Subject: FW: New West Stand SW Panel between home and away supporters

Subject: Screen Height Check

| WES LON DRAW ATH | ET TILE IT STAND REPLACEMENT IDON STADIUM ING TITLE LETICS CONFIGURATION - E ERAL ARRANGE MENT SCALE PAPIRE | | DEFIN | |

Attachments: image886549.png image463521.png ScreenHeightCheck.pdf

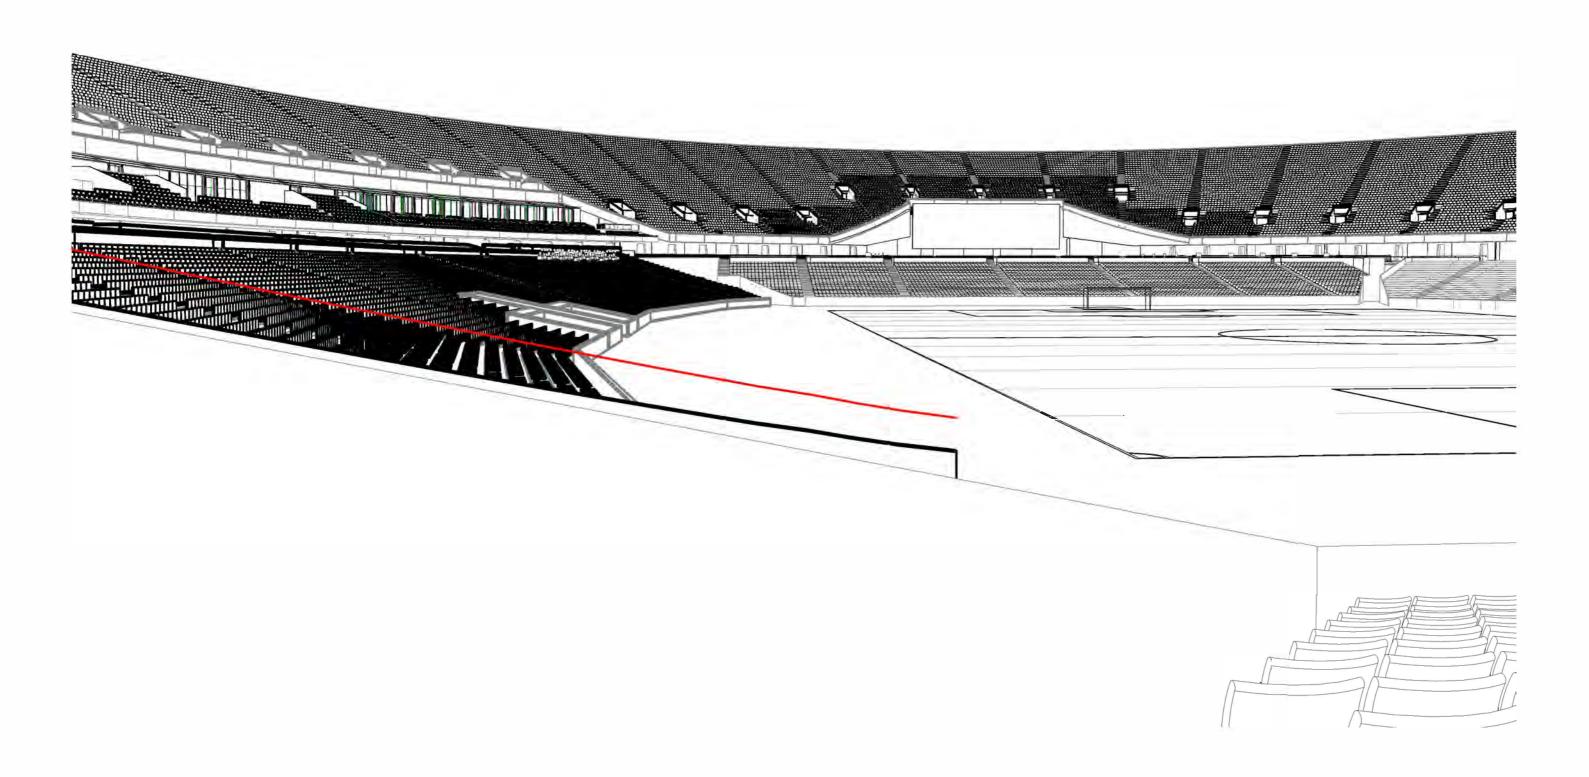
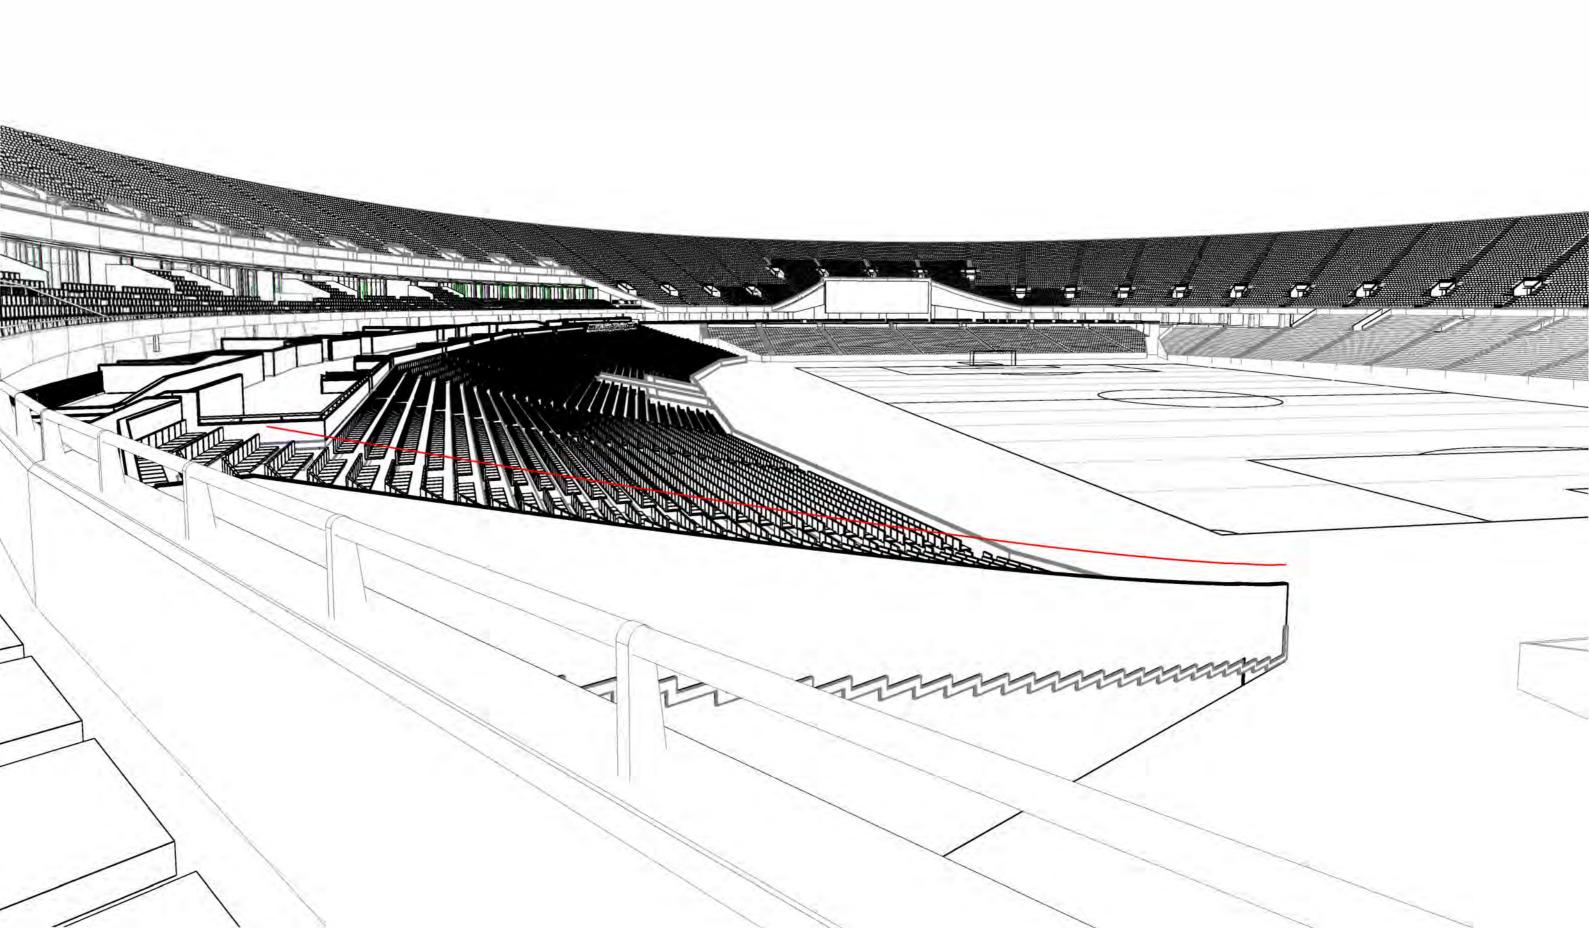
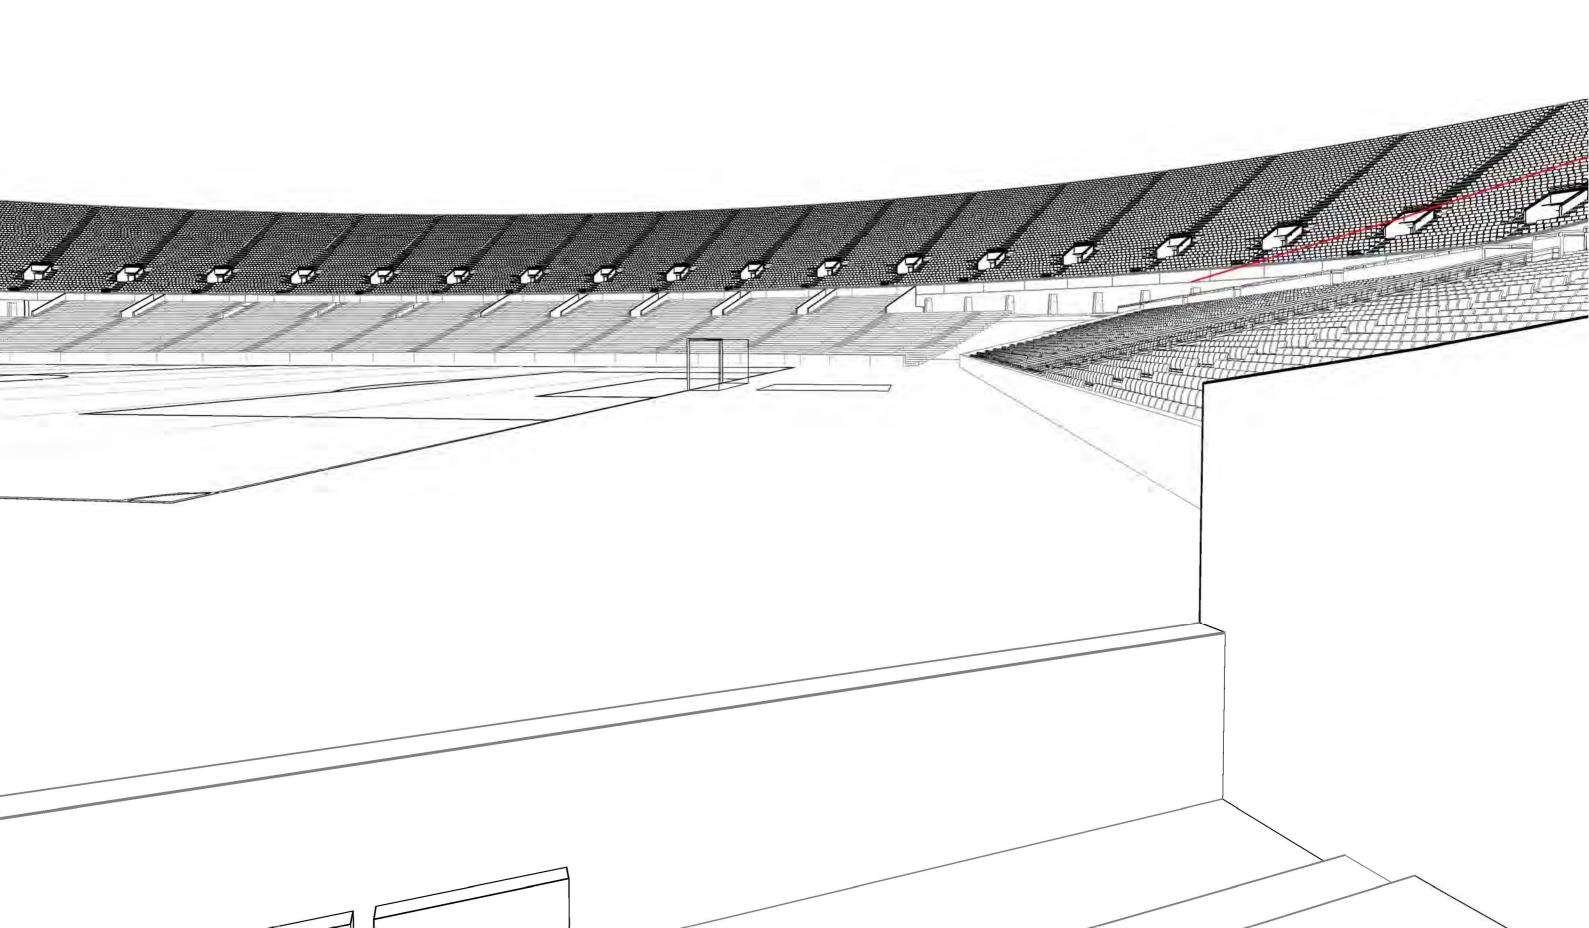
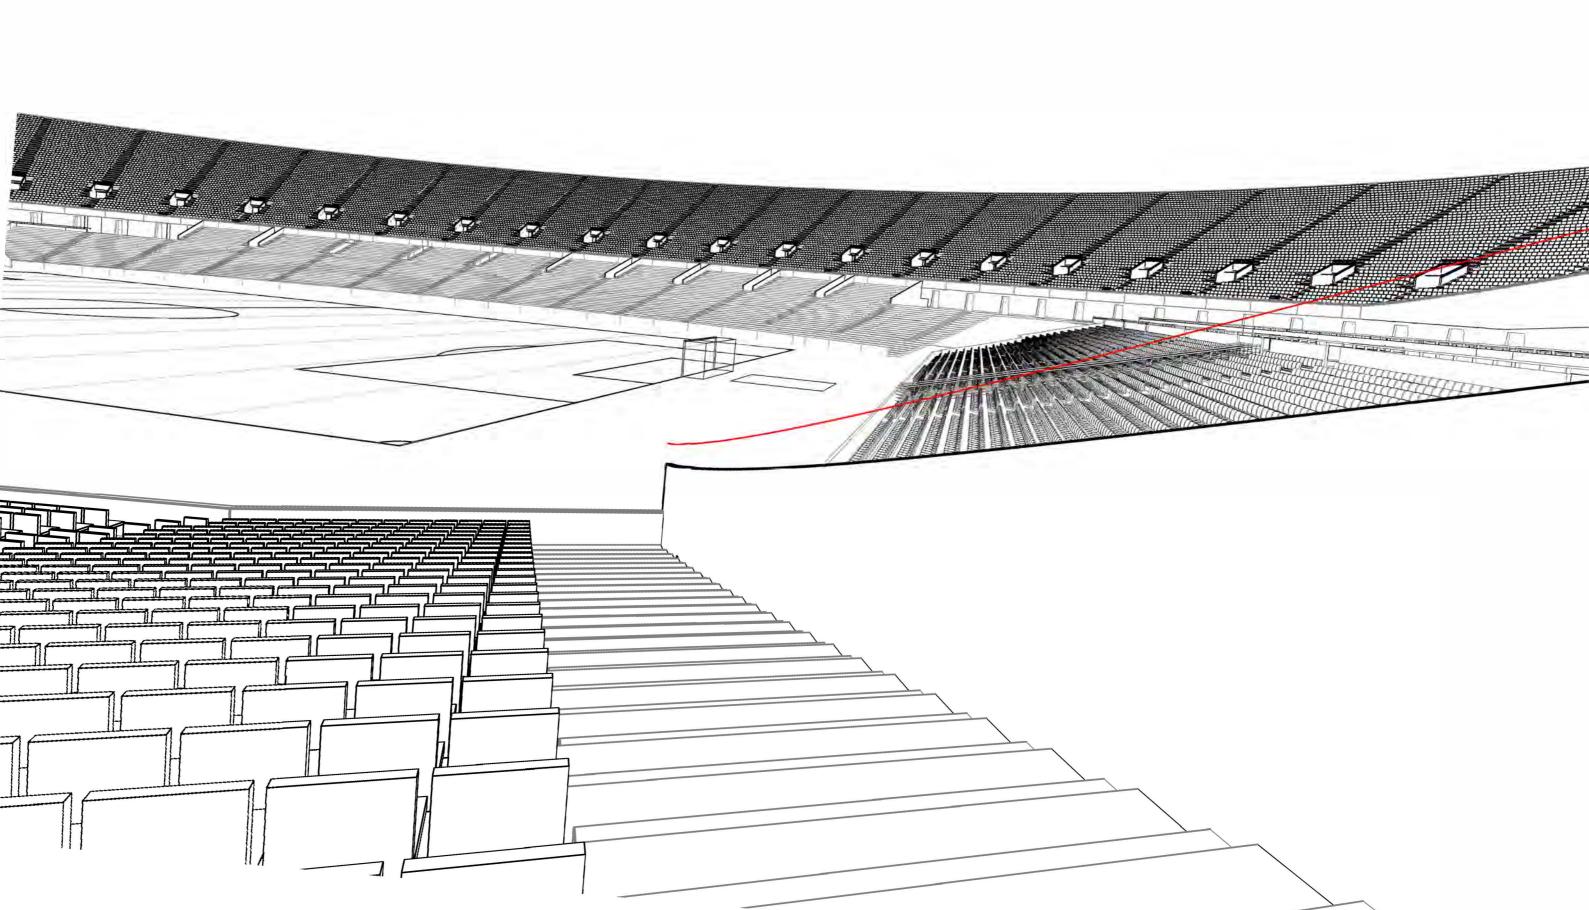
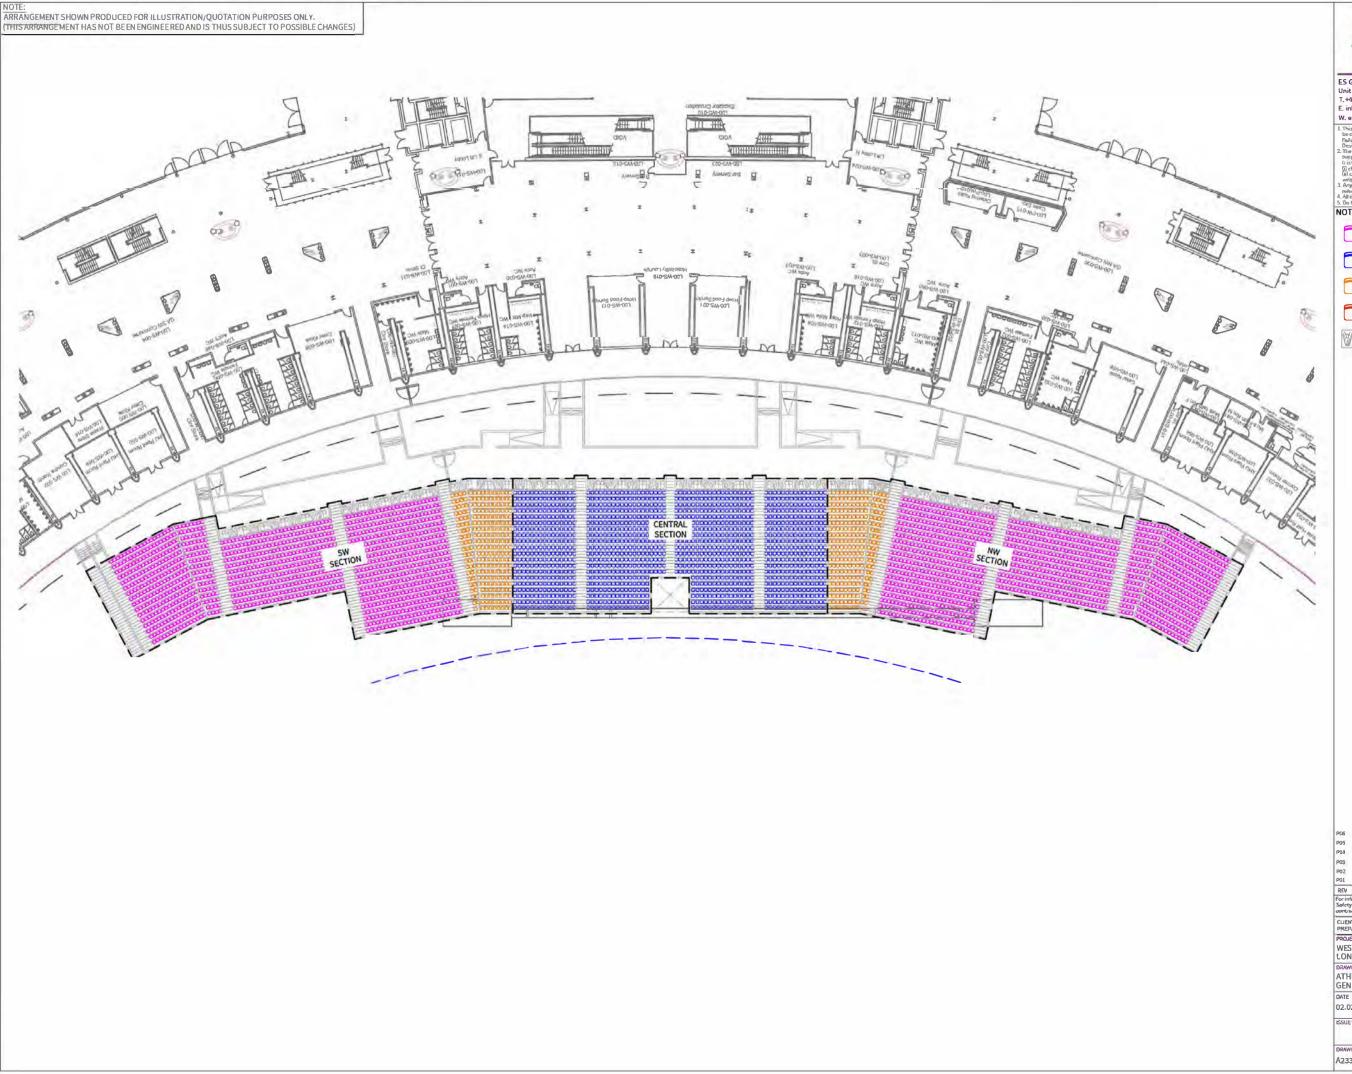
One of the things we discussed was the possibility of having some kind of netting to prevent/reduce the risk of things being thrown. Is this something that can be included as this has been installed at other PL grounds.

For me if there are no sight line problems the higher the better. I think what we have at the moment has been a massive improvement.

The images are of a 2m panel. The red line shows a 2.,5m height. There do not appear to be sightline issues from going to 2.5m, and it creates a better visual separation of home and away supporters.

reviewing from a safety operations perspective, and we are also e reviewing if a 2.5m panel is feasible; as well as what it means for other modes;. Could you give the club's thoughts so we can make a holistic decision.
